To: Planning Committee
From: Wayne Craig
Director, Development

Date: July 11, 2018
File: RZ 16-754046

Re: **Application by Bismark Consulting Ltd. for Rezoning at 9091 & 9111 No. 2 Road from Single Detached (RS1/E) to Low Density Townhouses (RTL4)**

TREE MANAGEMENT PLAN

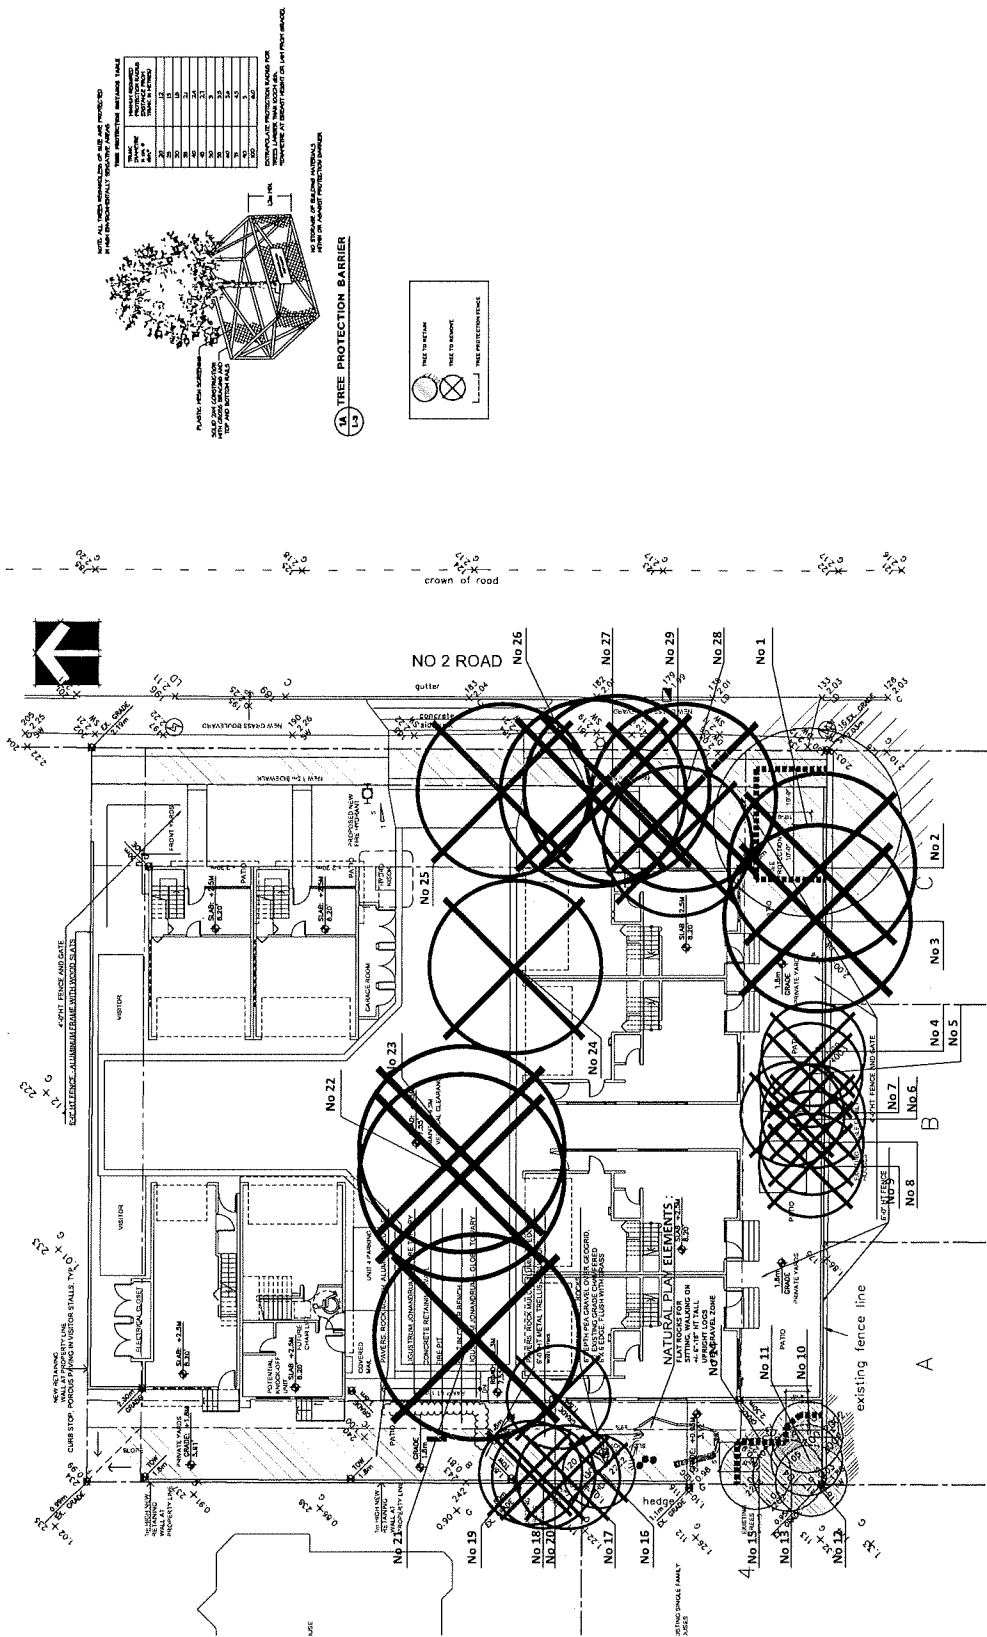
The City's Tree Preservation Coordinator has reviewed the Arborist's Report and Tree Management Plan (Attachment 4), conducted on-site visual assessment, and supports the Arborist's recommendations, with the following comments:

- One tree located in the southeast corner of the site (Tree # 1) is in good condition and is proposed to be retained and protected. It will be located in the proposed front yard. Provide tree protection as per City of Richmond Tree Protection Information Bulletin Tree-03

- Six trees located in the southwest corner of the site (Trees # 10-15) are in good condition and proposed to be retained and protected. They will be located in the proposed shared outdoor amenity area. Provide tree protection as per City of Richmond Tree Protection Information Bulletin Tree-03.

- 4 trees located on site (Tree # 16-19) are in good condition, but will be negatively impacted by the proposed grade changes to outdoor amenity area. Remove and replace.

- 18 trees located on site (Tree # 2-9, 20-29) are either dead, dying (sparse canopy foliage), infected with fungal blight, or exhibit structural defects such as cavities at the main branch union and co-dominant stems with inclusions. As a result, these trees are not good candidates for retention and should be removed and replaced.

- Replacement trees should be specified at 2:1 ratio as per the OCP.

Seven trees located on site (Tag # 1, 10-15) are to be retained and protected. The applicant has submitted a tree protection plan showing the trees to be retained and the measures taken to protect them during development stage (Attachment 4). To ensure that the trees identified for retention are protected at development stage, the applicant is required to complete the following items:

The applicant wishes to remove 22 on-site trees (Tag # 2-9, 16-29). The 2:1 replacement ratio would require a total of 44 replacement trees. The applicant has agreed to plant 19 trees in the proposed development. The required replacement trees are to be of the following minimum sizes, based on the size of the trees being removed as per Tree Protection Bylaw No. 8057.
